Meeting Date: Tuesday 15 September 2015
Location: Committee Room 2, Level 5, Civic Centre, 1 Devlin Street, Ryde
Time: 5.00pm

- 3 7 BRABYN STREET, DENISTONE EAST. LOT 12 DP 13432. Application pursuant to Section 96(2) of the Environmental Planning and Assessment Act, 1979 to modify an approved Demolition, new two storey dwelling, pool, and front fence. LDA2014/0340. Section 96 No MOD2015/0111.**

Assessment Summary – Proposed Window Modifications

Figure 1 shows the western elevation as approved under the original consent, while Figure 2 shows the proposed western elevation sought under this application.

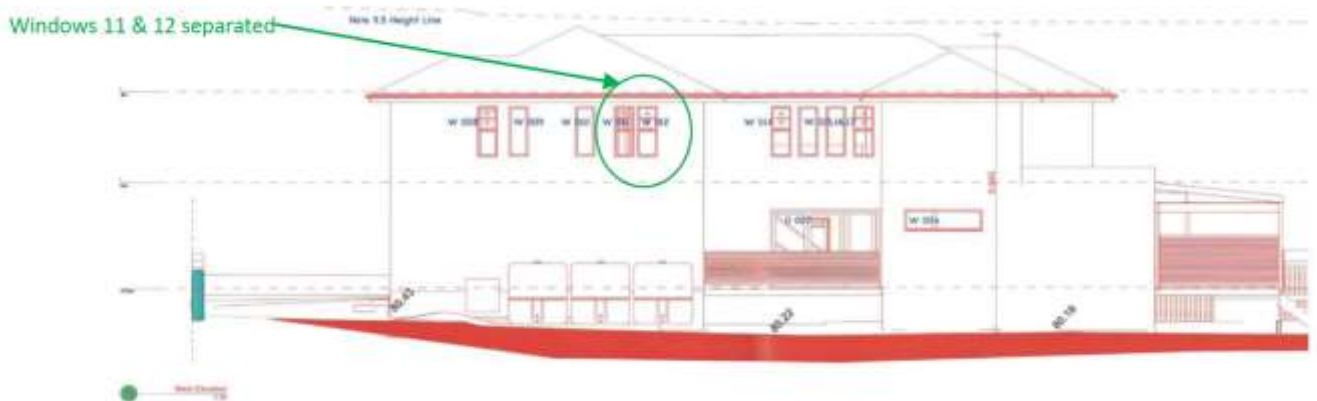
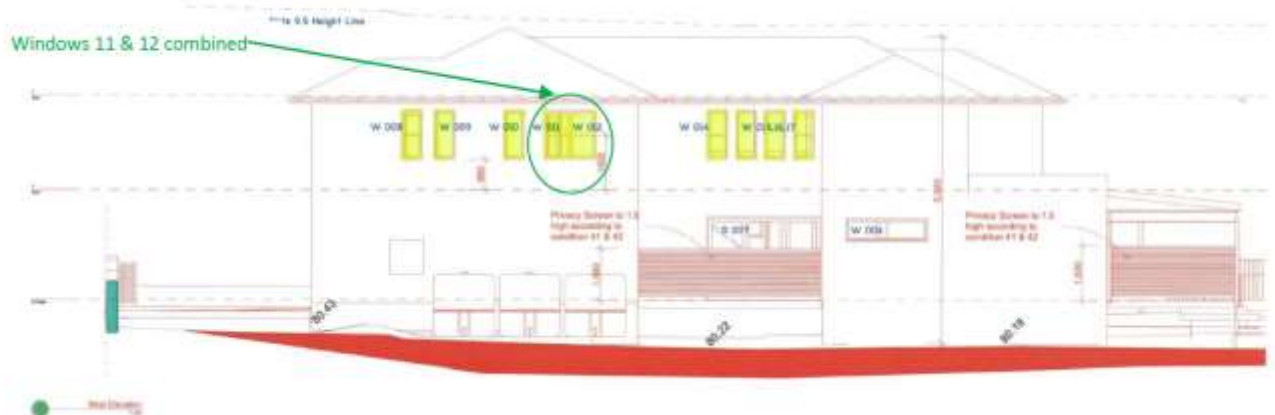
I believe the proposed building; with its modifications will have a significant impact on my amenity with regard to loss of visual privacy and acoustic privacy.

All the windows on the second level will impose on the visual privacy of my residence.

The only modification to the windows that is considered to result in the potential for increased impact is Windows 11 & 12 (Bedroom 3). The original DA included two (2) windows to this bedroom on the western elevation which are now proposed to be combined and modified as follows and shown at Figure 3:

While the proposed combined Window 11&12 results in a larger window off Bedroom 3, the proposed modification does not result in unacceptable privacy impacts to the adjoining property when sight lines, the use of rooms and materials are considered as follows:

Thus, despite the increased size of Window 11&12 there is not considered to be any unacceptable privacy impacts as a result of the proposed modification.

Further, Section 2.14.2 of Part 3.3 of Ryde DCP 2014 provides controls regarding visual privacy for dwellings and aims to minimise overlooking of neighbouring dwellings. This section states that “*Overlooking from bedroom windows is less of a concern than overlooking from the windows of other habitable rooms.*” Being from Bedroom 3, the impact of the increased window size is not considered to be unacceptable.

Figure 3. Proposed first floor aligned with ground floor of No. 5 Brabyn

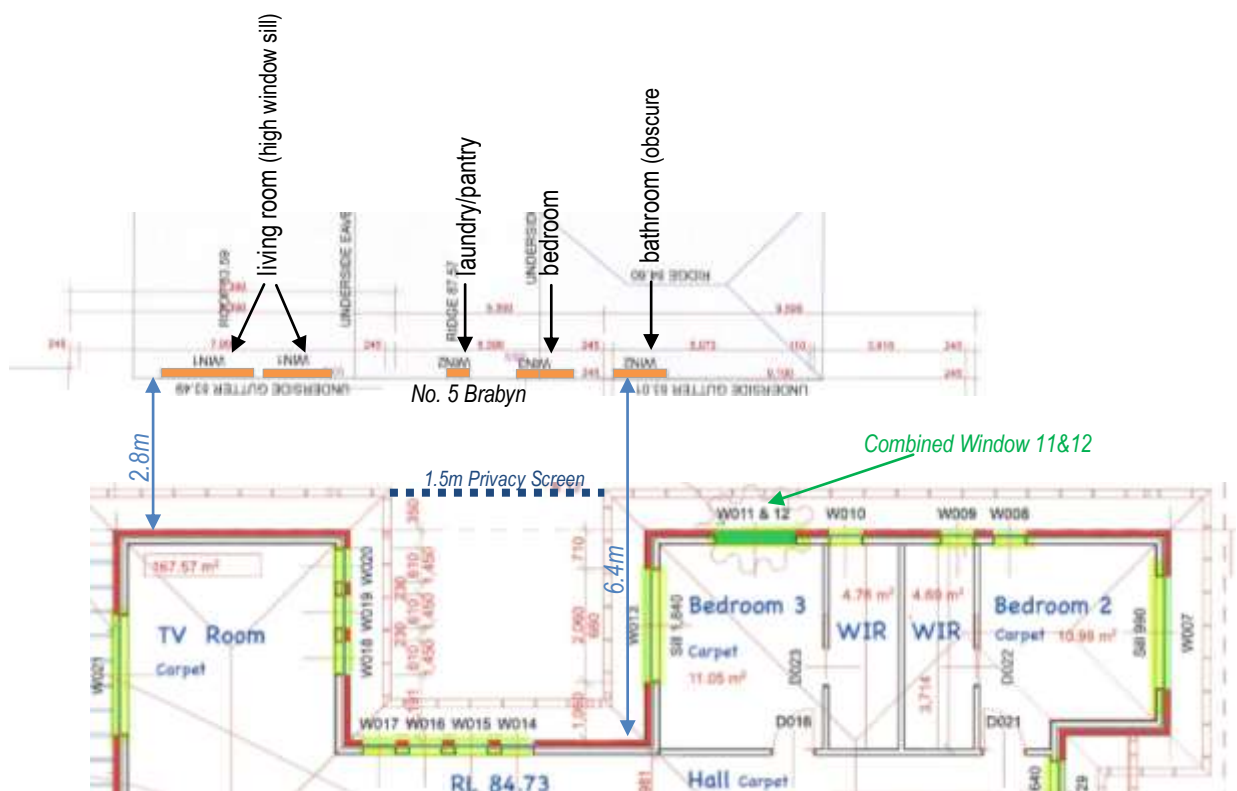
Approved: Windows 11 and 12

Proposed: Combined Window 11&12

- The first floor of No. 5 Brabyn has only one window, none of which face the subject site (see Photo 1), and the combined window does not directly align with the first floor window, nor with any windows on the ground floor (refer Figure 1).

- The nearest window of No. 5 Brabyn to Window 11&12 is the two bathroom windows which have obscured glass (see Photo 3). These are narrow windows and are double hung which will prevent the opportunity for overlooking from Window 11&12 into the bathroom.
- The next nearest window at No. 5 Brabyn to Window 11&12 is the bedroom window (refer Figure 1). This window is considered to be at a sufficient distance away to prevent any direct view between these rooms.

Figure 4. Ground floor deck courtyard and ground floor windows of No. 5 Brabyn

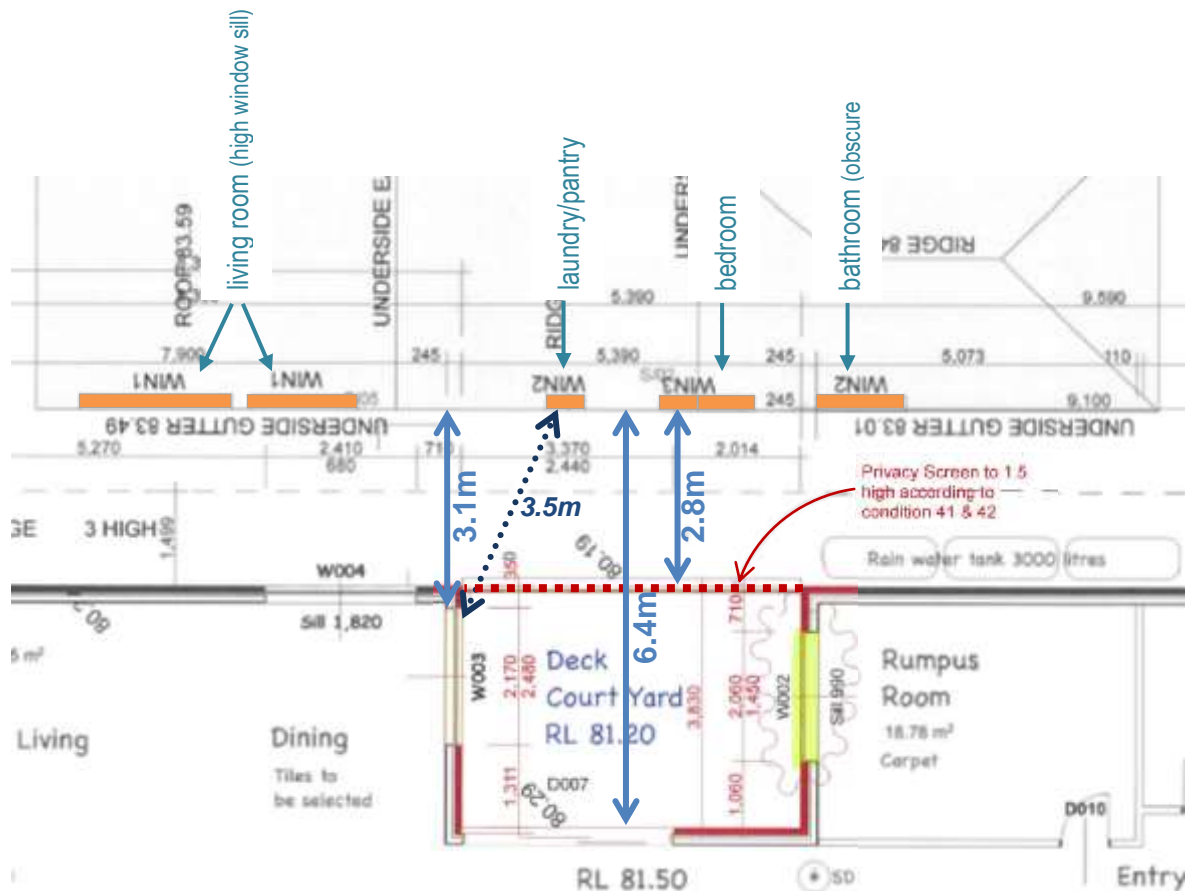
The deck courtyard itself, on the ground level is likely to have a significant impact on our acoustic privacy as the rooms either side of the courtyard are designated dining/living room to one side and rumpus/home theatre to the other.

The submission raises concern relating to acoustic impacts of the side courtyard and living spaces off the side courtyard. The approved courtyard ground floor is setback 2.8 to 6.4m from the façade of No. 5 Brabyn, with inwards courtyard facing windows setback a minimum 3.1m from the façade of No. 5 Brabyn. The minimum window-to-window distance between the approved windows facing the courtyard and the windows of No. 5 Brabyn is 3.5m as shown at Figure 4.

“As for the potential acoustic impacts from this room [the dining room and rumpus room adjoining the courtyard], they are considered to be acceptable given that sufficient separation will be provide between the dwellings with the proposed side setbacks complying with requirements from Ryde DCP2010.”

No modification is proposed to the courtyard area of the development, and the proposed changes to the windows facing the courtyard will not increase or exacerbate any impacts that were considered acceptable under the original consent.

GROUND FLOOR

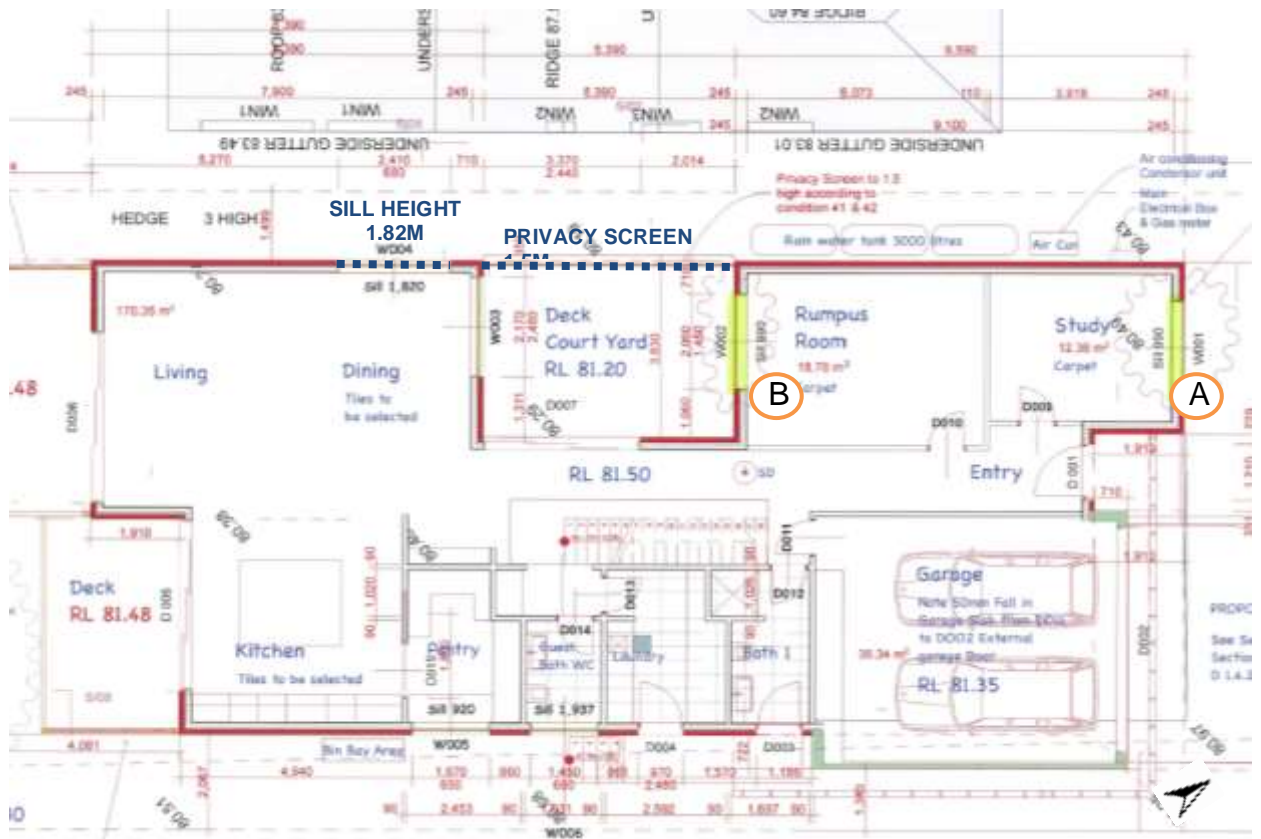
Ref	Window /Room	Setback From No. 5	View	Comment	Impact/Size Of Window
GROUND FLOOR					
A	Window 1/ study	N/A	Towards street	Approved Width: 2060mm. No change to width proposed. Approved Height: 2140mm Proposed Height: 1450mm Window area reduced from 4.4084m² to 2.987m².	Reduced
B	Window 2 / Rumpus Room	Min. 4m sight line distance	S/ SW Screened by privacy screen along the courtyard of 1.5m	Approved Width: 1810mm. Proposed Width: 2060mm. Approved Height: 1500mm Proposed Height: 1450mm Window area increased from 2.71m² to 2.99m²	Window size increased. Screened by privacy screen. The 0.28m² increase will not cause additional impacts as a result of the window size.
FIRST FLOOR					
C	Window 7/ Bed 2	N/A	Towards street	Approved Width: 2060mm. No change to width proposed. Approved Height: 1540mm Proposed Height: 1450mm Window area reduced from 3.1724m² to 2.987m².	Reduced
D	Window 8/ Bed 2	2.8m	West	Width: 610mm. No change to width proposed. Approved Height: 1530mm Proposed Height: 1450mm Window area reduced from 0.933m² to 0.8845m²	Reduced

FIRST FLOOR

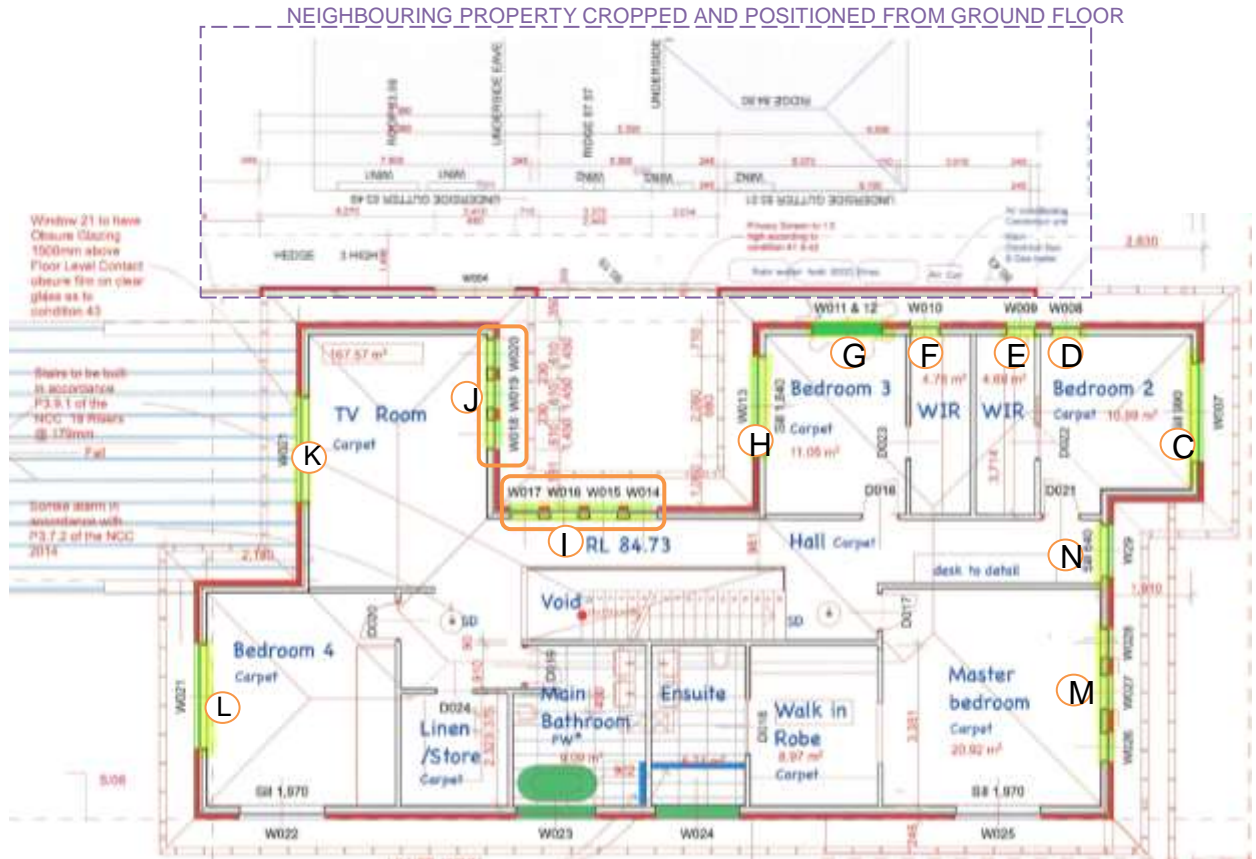
Ref	Window /Room	Setback From No. 5	View	Comment	Impact/Size Of Window
E	Window 9/ Walk in Robe of BR2 <i>Obscure Glass</i>	2.8m	West	Width: 610mm. No change to width proposed. Approved Height: 1530mm Proposed Height: 1450mm Window area reduced from 0.933m² to 0.8845m².	Reduced
F	Window 10/ Walk in Robe of BR3 <i>Obscure Glass</i>	2.8m	West	Width: 610mm. No change to width proposed. Approved Height: 1530mm Proposed Height: 1450mm Window area reduced from 0.933m² to 0.8845m²	Reduced
G	Window 11 & 12 / Bed 3	2.8m	West	<u>Approved: W11 & W12:</u> Height:1530mm Width: 610mm each 1220mm total 110mm gap Area: 0.933m² each 1.866m² total <u>Proposed: Combined W11/12</u> Height:1450mm Width: 1500mm combined. Area: 2.175m²	Increased.
H	Window 13/ Bed 3	Min. 4m sight line distance	South West	Sill height approved: 1970mm Sill height proposed: 1840mm Approved Width: 1810mm. Proposed Width: 2060mm. Approved Height: 680mm Proposed Height: 680mm Overall window area increased from 1.2308m² to 1.4008m²	Window size increased. Sill height is still above eye level. The 0.17m² increase will not cause additional impacts as a result of the window size.

Ref	Window /Room	Setback From No. 5	View	Comment	Impact/Size Of Window
I	Windows 14 – 17 / Hall	6.63m	West	Sill height approved: 890mm Sill height proposed: 990mm Width: 610mm. No change to width proposed. Approved Height: 1530mm Proposed Height: 1450mm Overall window area reduced from 0.933m² to 0.8845m².	Reduced
J	TV Room/ Windows 18-20	Min. 4m sight line	North West	Sill height approved: 890mm Sill height proposed: 990mm Width: 610mm. No change to width proposed. Approved Height: 1530mm Proposed Height: 1450mm Overall window area reduced from 0.933m² to 0.8845m².	Reduced
K	TV Room/ Window 21A	N/A	South	Only change - Sill height increased by 100mm. Window 21A to have obscure glazing 1500mm above floor level.	Nil.
L	Window 21/ Bed 4	N/A	South	Only change - Sill height increased by 100mm.	Nil.

Ref	Window /Room	Setback From No. 5	View	Comment	Impact/Size Of Window
M	Master Bed/ Windows 26-28	N/A	North	Sill height approved: 900mm Sill height proposed: 990mm Approved Width (all): 730mm. Proposed Width (W26&28): 610mm Proposed Width (W27): 730mm Approved Height: 1530mm Proposed Height: 1450mm Overall window areas reduced: W26 & W28: 1.1169m² to 0.8845m² W27: 1.1169 m² to 1.0585m²	Reduced
N	Front of Hallway/Window 29	N/A	North	No change proposed.	Nil
